Product Change Notification: PCN-22-126851

General Product Description:	
Packing specification change

Packing change: Add the mirror mat

Fig,1

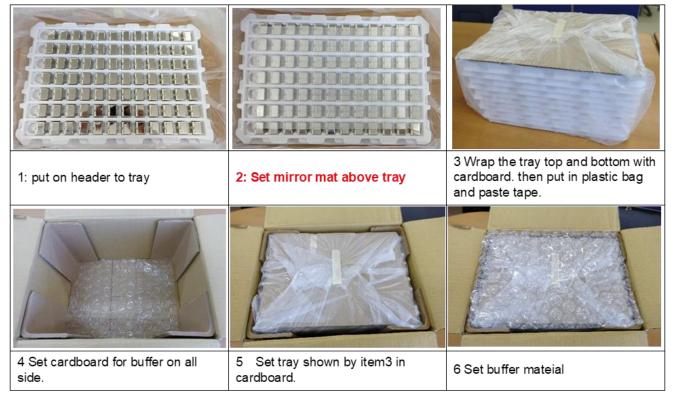
• Mirror mat is added between tray and tray as shown Fig1.

Packing change point. Add item2
